SB-10043568-6631

WABCO 6S6M - 10 A Fuse to be used at location F11-D 4azx

ProStar, LoneStar, TranStar

ProStar Fuse Location Shown Below

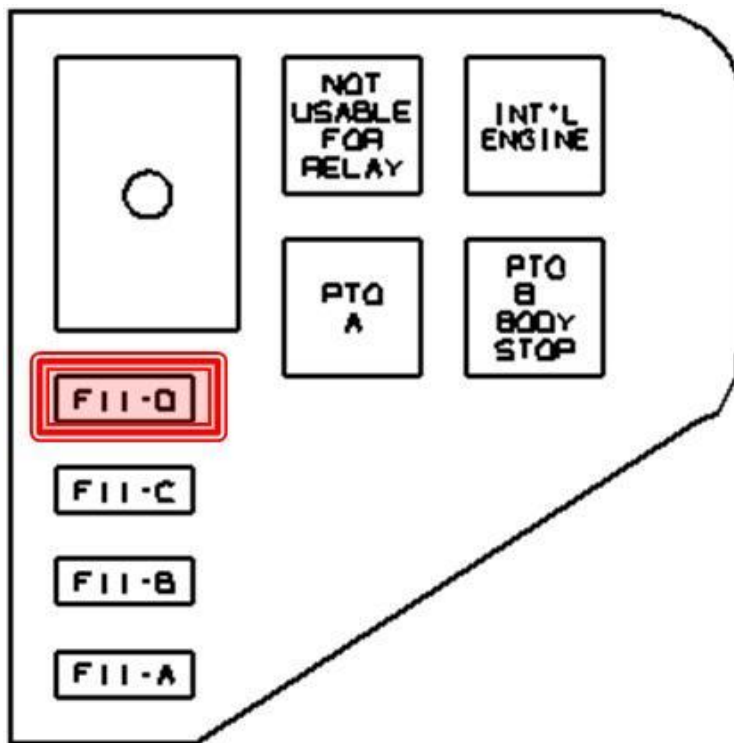
WABCO 6 Sensor 6 Modulator has an incorrect 5Amp fuse at location F11-D.

- Fuse at F11-D is failing due to rating of 5 Amp

Replace the fuse (location F11-D) with a 10 Amp fuse

Wabco 6 Sensor 6 Modulator
Uses 10 Amp
